C — HEAT SHIELD ASS'Y DESCENT STAGE - REMOVABLE BASE

LDW280-25662 — C5

GRUMMAN AIRCRAFT ENGINEERING CORP

GRUMMAN AIRCRAFT ENGINEERING CORP.
CODE IDENT NO. 26512
ENGINEERING ORDER

DWG. NO. LDW280-25642 | EO NO. E1
CONTROL INFO NO. LDW280A 5344

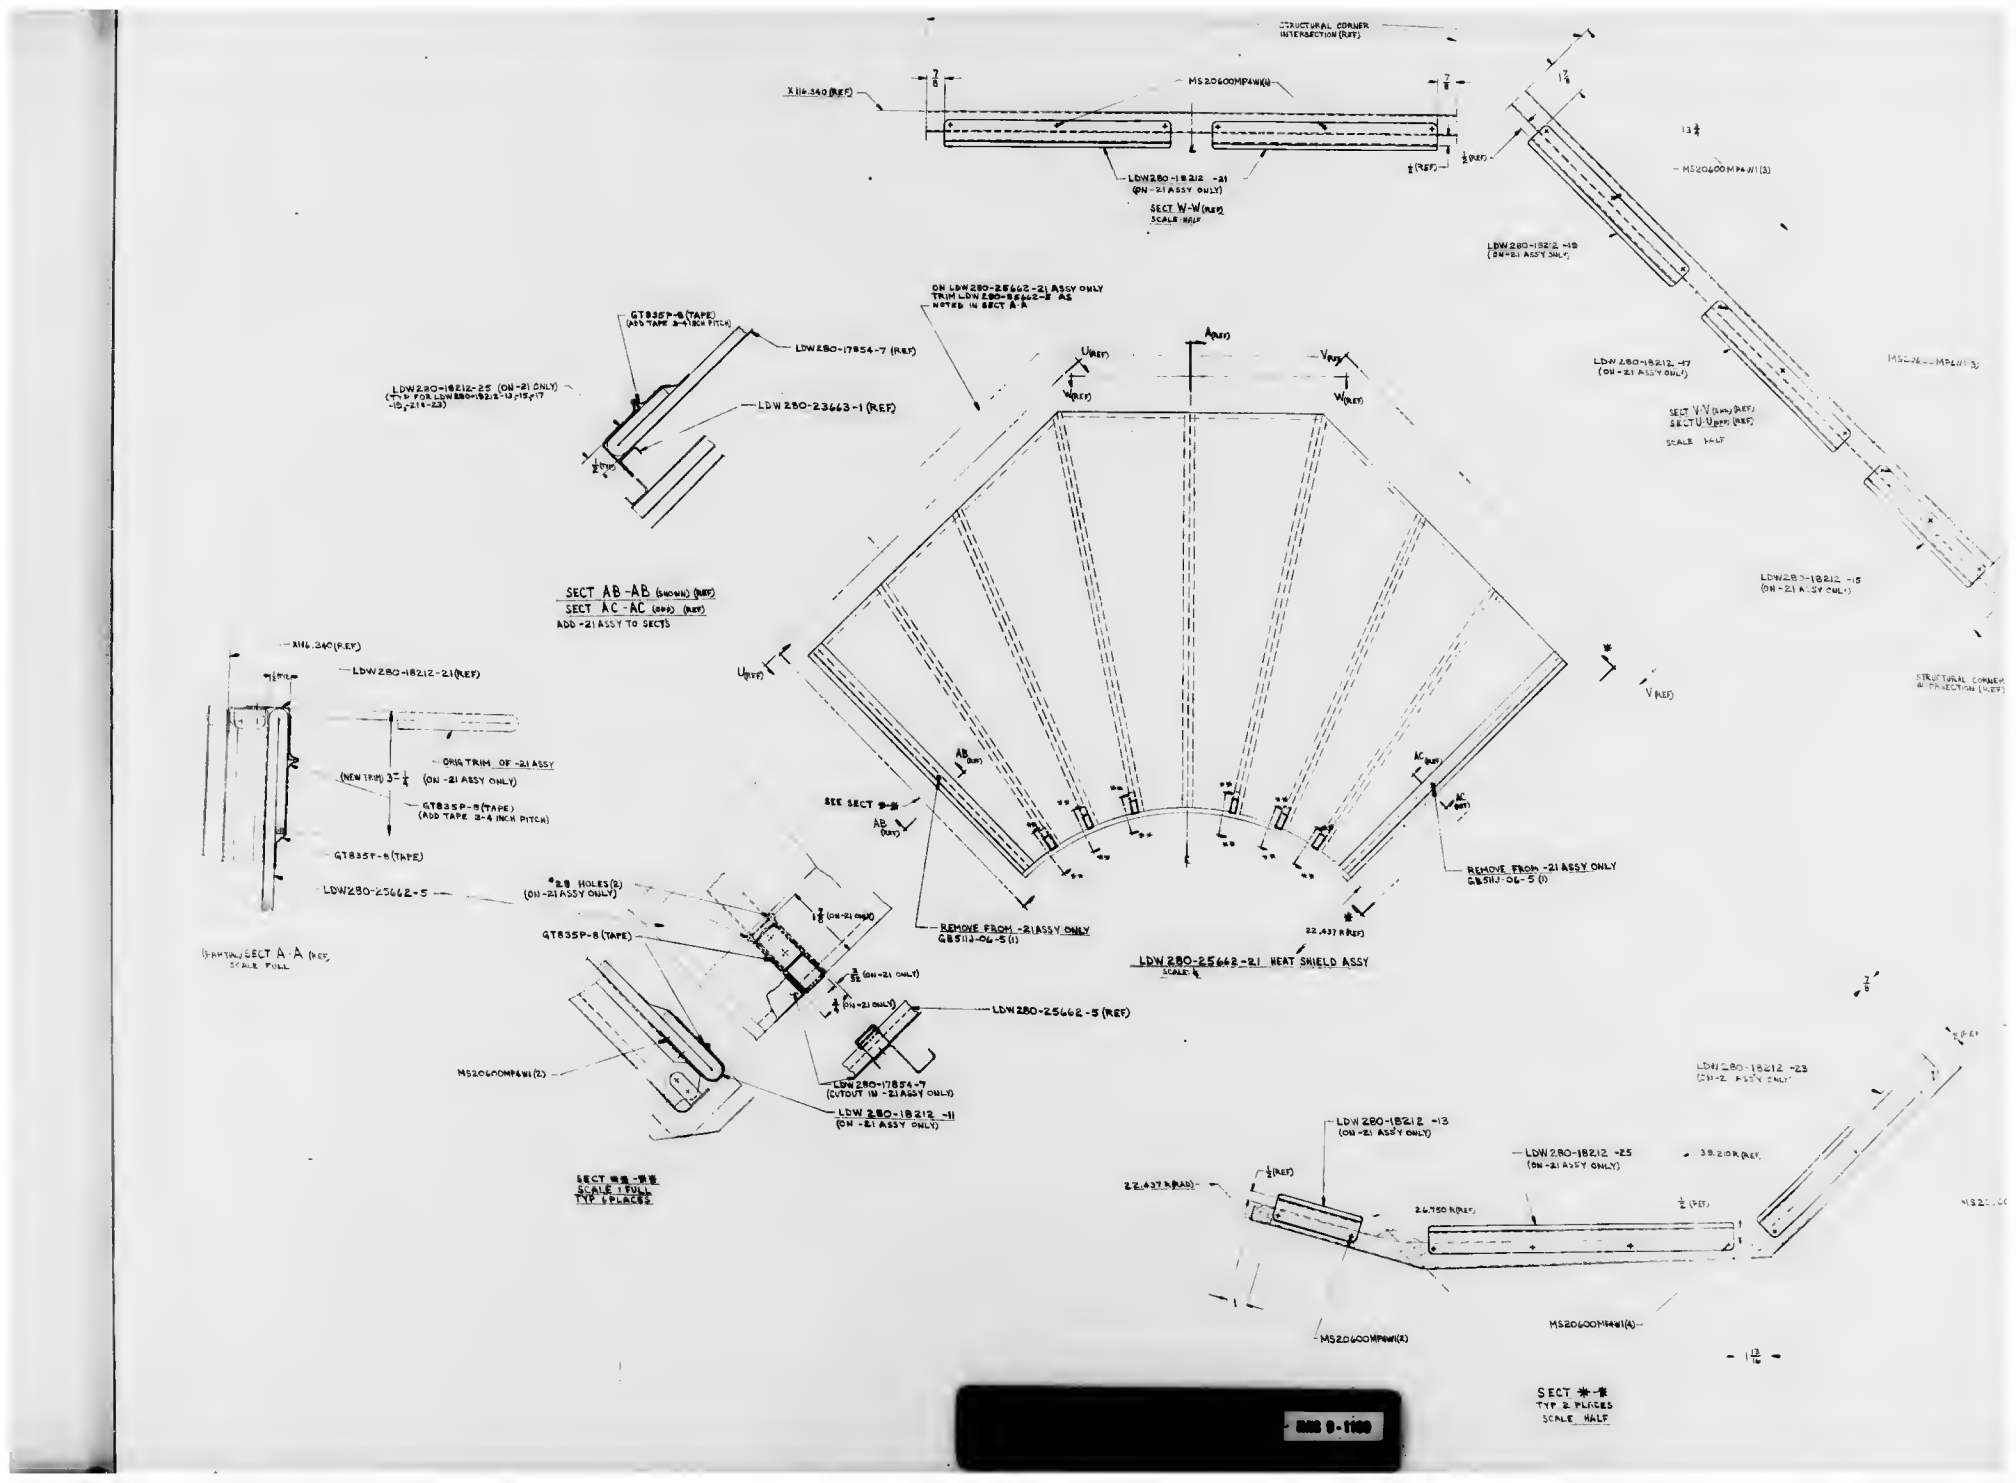
ADDED LDW 280-18212-11,-13,-15,-17,-19,-21,-23 & -25 & MS20600MP4W1(54) TO LDW280-25662-21 ASSY. 1 REQD/MOD OF LDW280-25662-21 WAS 2 REQD. REMOVED GB511J-06-5(2) FROM -21 ASSY; ADDED SECT *-* & SECT **-** ... CUTOUTS IN LDW280-17054-7 ON -21 ASSY ONLY ... REMOVED -21 ASSY FROM DETAIL ... ADDED -21 ASSY TO SECTS ...

LCR #960		
REASON FOR EO: ADD'L LENGTH REQD LCR 960	DESCRIPTION OF EO: ON -21 ADD LDW280-17540-23 (3), MS20615-4M3 (54) MS20600MP4W1 (4) SECT *-* & Δ-Δ, TRIM LDW280-18212-25	
MODEL: LM	EFFECTIVITY: QUAL TST (10)	
PRIORITY: C	DRAWING TITLE: SHIELD ASS'Y	DRAWING NO: LDW280-25642 / EO NO. E1

DWG. NO. LDW280-25680 | EO NO. B1

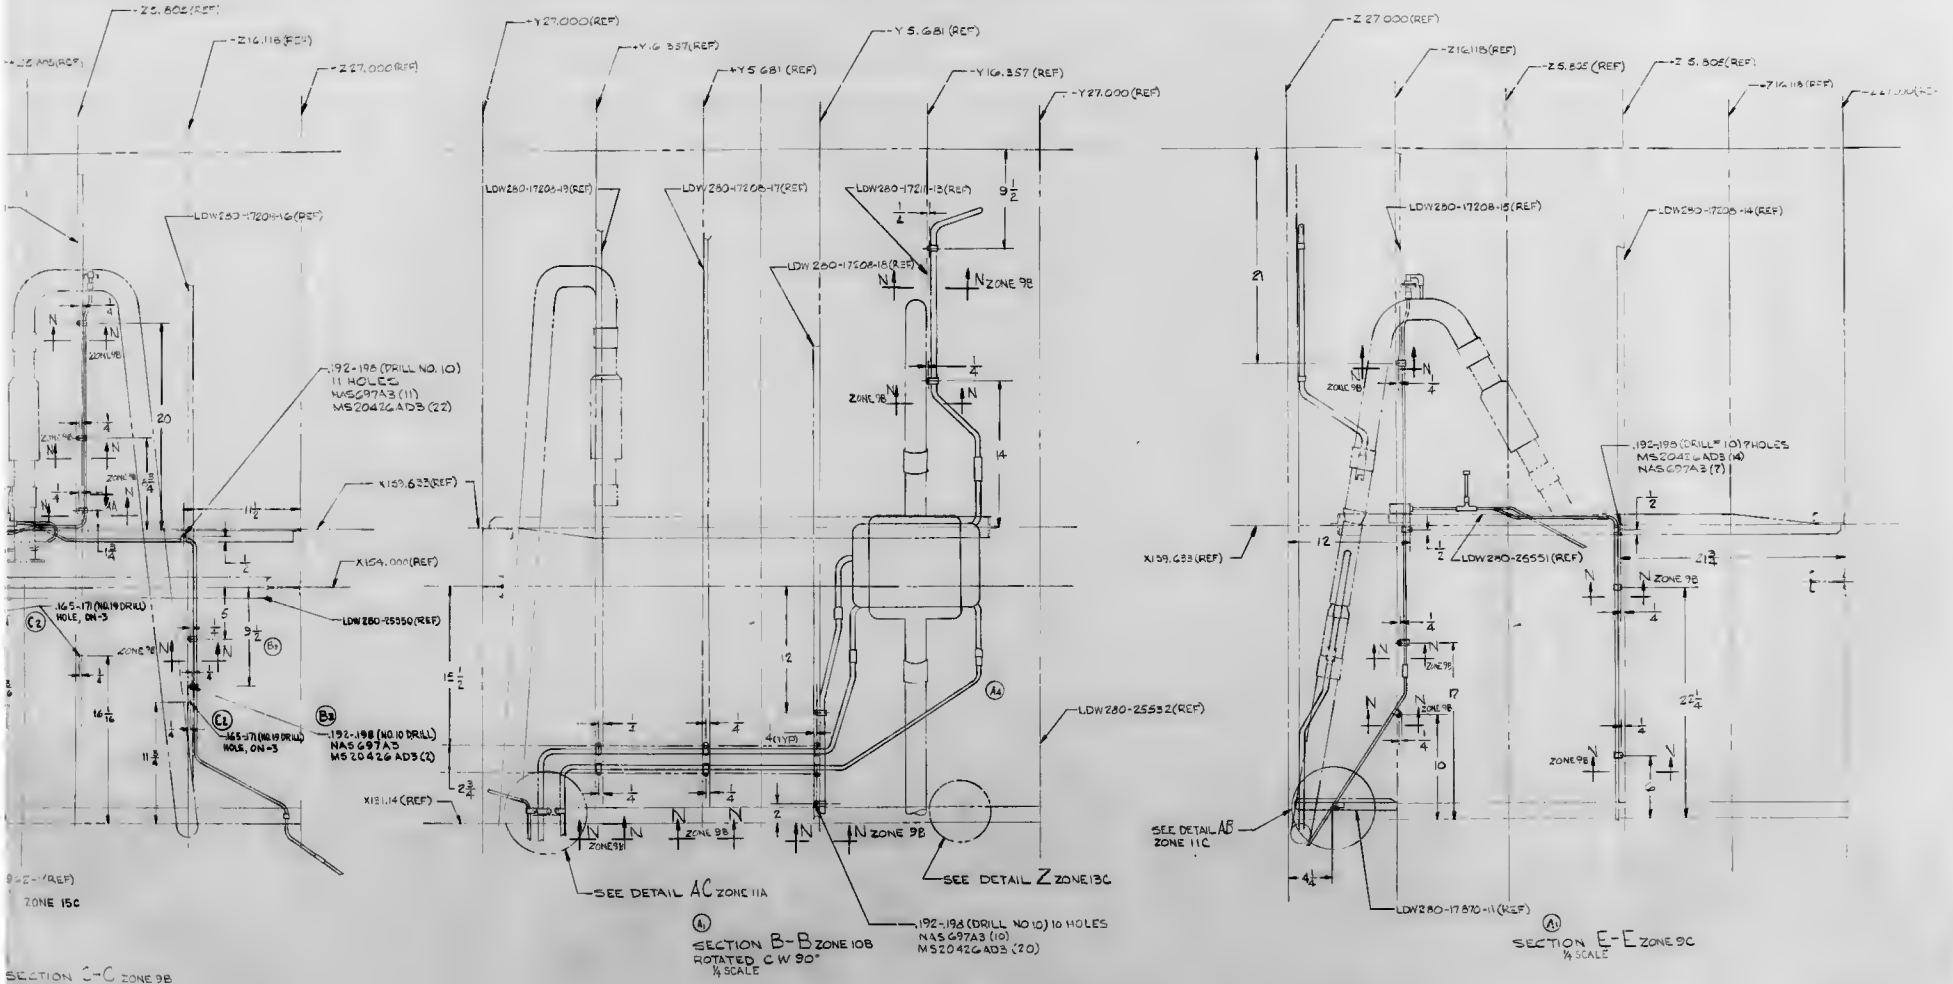
-1 INSTL -
RELOCATE LDW280-17769-15 & ADD LDW280-17769-17 DOUBLER TO B/M 6 F/D AS SHOWN:

CHANGE ALL OTHER VIEWS TO AGREE WITH CHANGE.

DESCRIPTION OF EO: -1 INSTL, ADDED LDW280-17769-17, MS20470DD4(7); RELOCATED LDW280-17769-15.

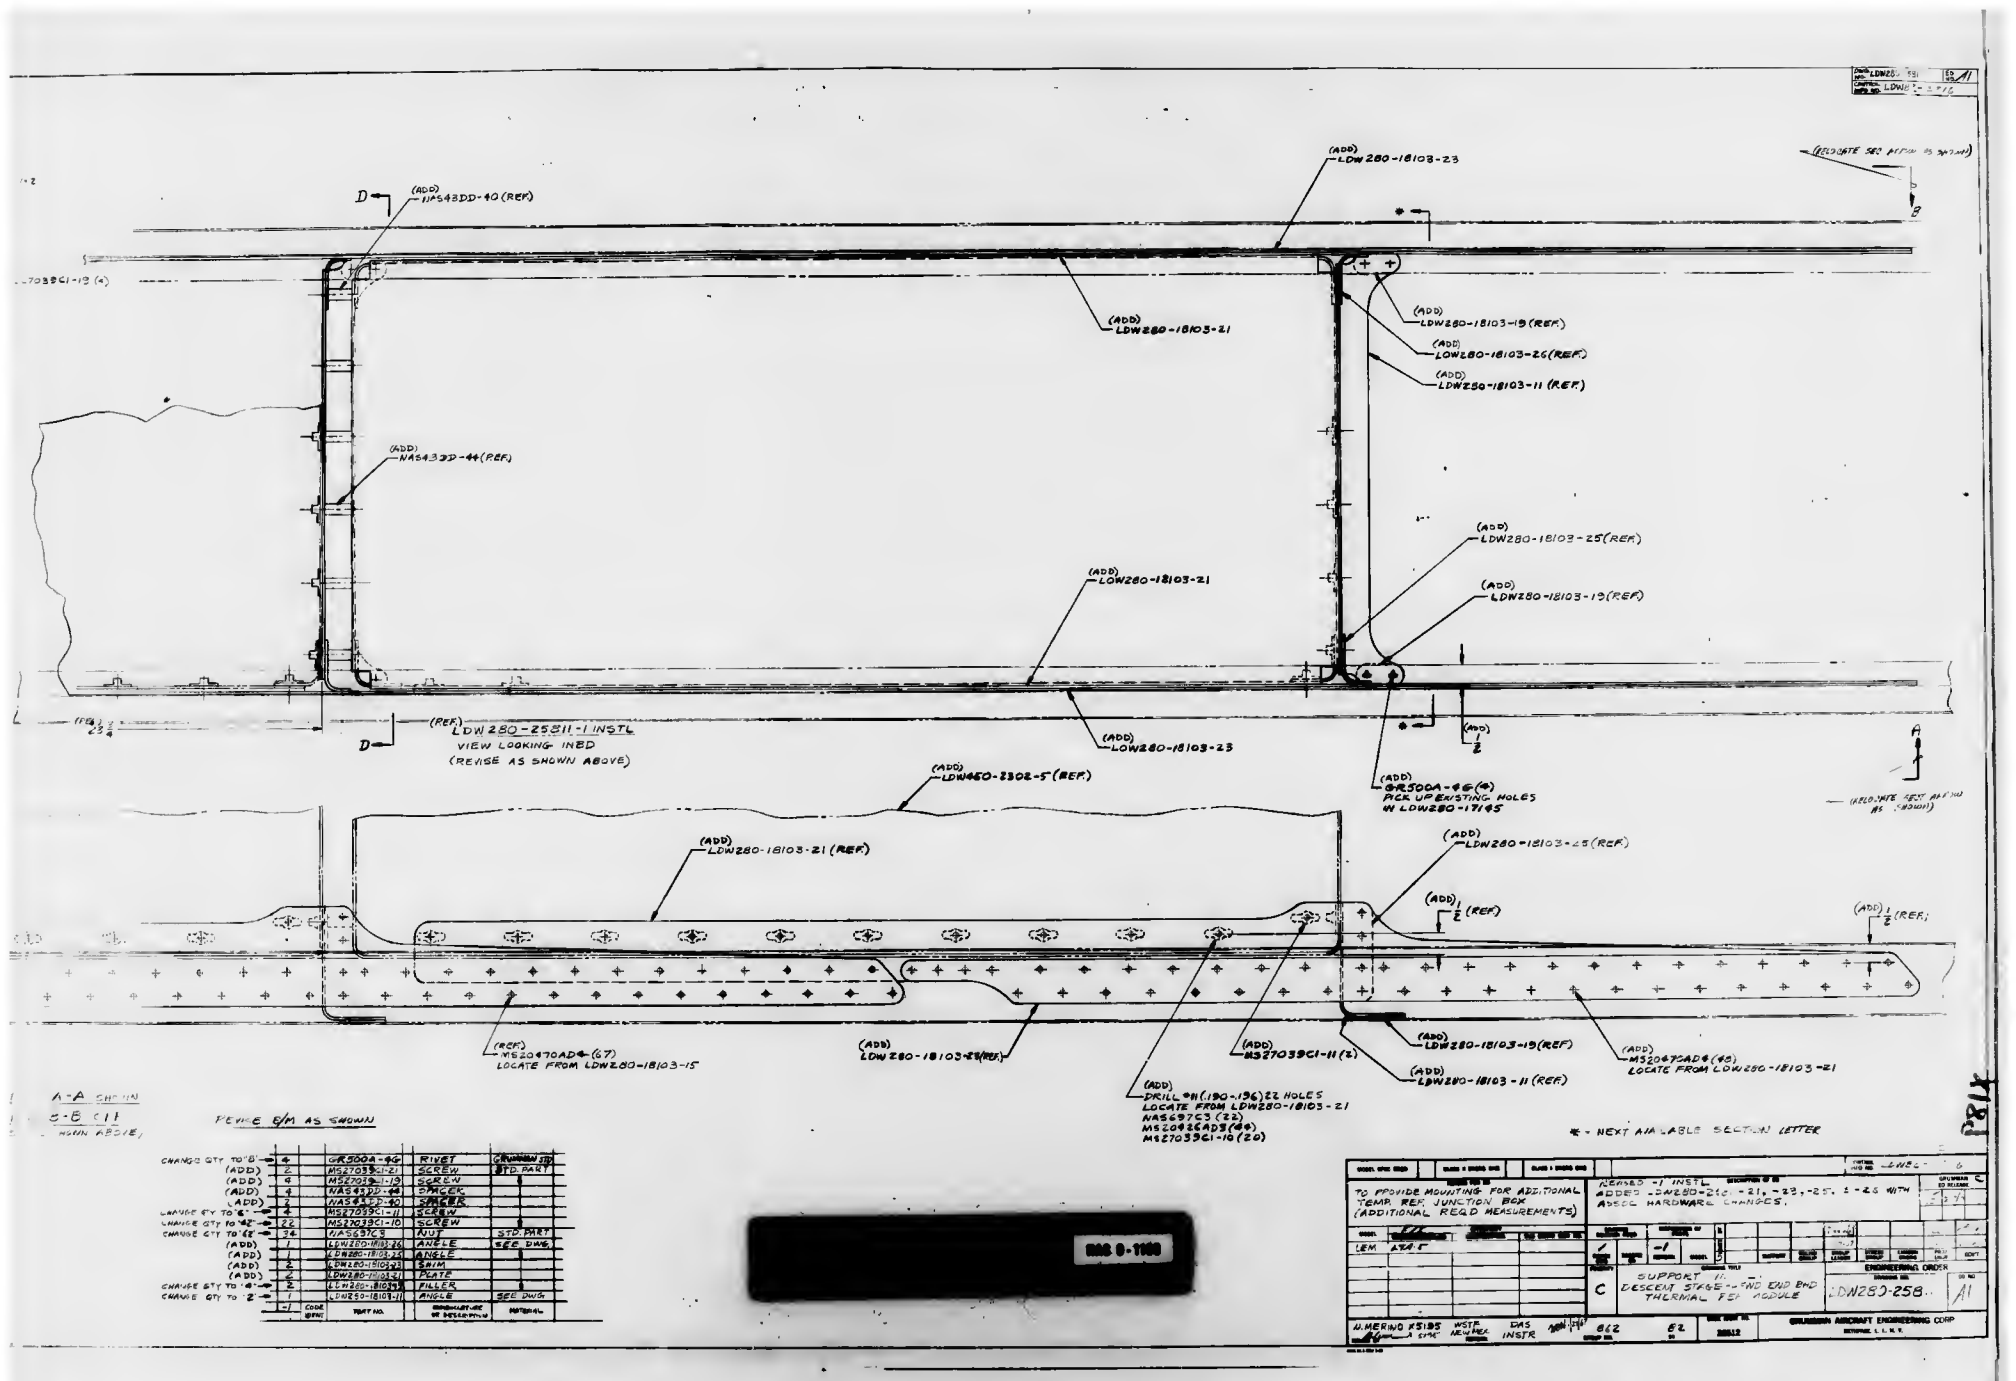
REVISE E/M AS SHOWN

CHANGE QTY TO "8" →	4	GR500A-66	RIVET	GRUMMAN STD PART	
(ADD)	2	MS27039C1-21	SCREW		
(ADD)	6	MS27039C1-19	SCREW		
(ADD)	4	NAS43DD-44	SPACER		
(ADD)	2	NAS43DD-40	SPACER		
CHANGE QTY TO "6" →	4	MS27039C1-11	SCREW		
CHANGE QTY TO "42" →	22	MS27039C1-10	SCREW		
CHANGE QTY TO "68" →	34	NAS697C3	NUT	STD. PART	
(ADD)	1	LDW280-18103-26	ANGLE	SEE DWG.	
(ADD)	1	LDW280-18103-25	ANGLE		
(ADD)	2	LDW280-18103-23	SHIM		
(ADD)	6	LDW280-18103-21	PLATE		
CHANGE QTY TO "4" →	2	LDW280-18103-19	FILLER		
CHANGE QTY TO "2" →	1	LDW250-18103-11	ANGLE	SEE DWG.	
	-1	PART NO.		MATERIAL

REVISED -1 INSTL
ADDED LDW280-21C -21, -23, -25, & -26 WITH ASSOC. HARDWARE CHANGES.

TO PROVIDE MOUNTING FOR ADDITIONAL TEMP. REF. JUNCTION BOX (ADDITIONAL REQ'D MEASUREMENTS)
